27 November 2024
Document No. 60.01029.01 LTR1D1.DOCX

Consultant Advice Notice (DRAFT)
102 Wyndam Street, Alexandria, NSW
Noise & Vibration Review - New Health Research Facility (SSD-63067458)

Figure 3. Proposed Basement Excavation and Proximity of 102 Wyndam Street

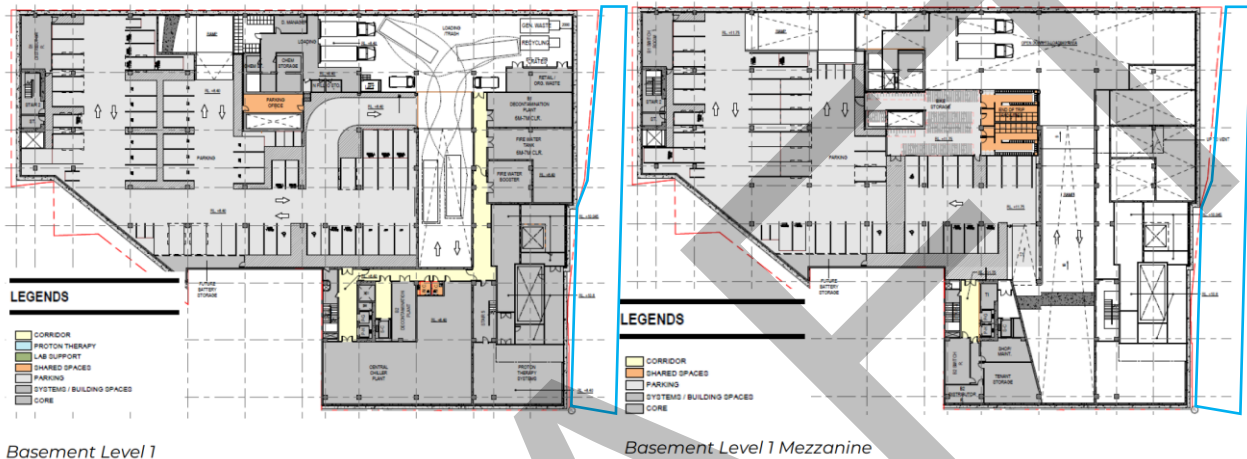
The residential building of 102 Wyndam Street is located right on the edge of the boundary. Any excavator or heavy machinery operating on the Project excavation would be within 1 – 2 m of the 102 Wyndam Street facade.

Table 28 of the NVIA reports worst-case noise levels of 93 dB LAeq at R1 (102 Wyndam Street) during the excavation using an excavator with hammer. Table 27 of the NVIA shows that the excavator with hammer has a sound power level of 115 dB LW and that this machine can operate anywhere on site.

Our calculation of the noise levels when the excavator with hammer operates at the boundary (during excavation of the basement) shows potential noise levels in excess of 100 dB LAeq. Based on a simple calculation the NVIA noise level appears to be low.

A level of 93 dB LAeq at R1 would mean the excavator is located approximately 5 m away at all times along the entire boundary of the excavation.

The hammering head of the excavator must operate along the boundary of the excavation area so would be within 1 – 2 m of the 102 Wyndam facade.

How have the excavation noise levels been calculated?

Figure 3 above shows that the excavation of the basement levels will be within 1 – 2 m of the 102 Wyndam Street building facades. Excavators with hammers can generate high vibration levels at this distance. It is not unusual to see vibration levels in excess of cosmetic damage criteria and possibly structural damage criteria if shared structural foundations between buildings are impacted by the machines.

At this distance the impacts of ground borne vibration and structure borne noise would easily exceed human comfort criteria.

Why does the NVIA report not predicted ground borne vibration and structure borne noise levels at the nearest affected receivers to the basement excavation?

The NVIA should report how the calculations have been made and show construction noise levels for the worst-affected facades for each receiver not just for the group R1.

The NVIA should report the construction vibration levels, durations of impacts and provide suitable mitigation measures as per the guidance in *Assessing Vibration: A Technical Guideline (DEC 2006)*.
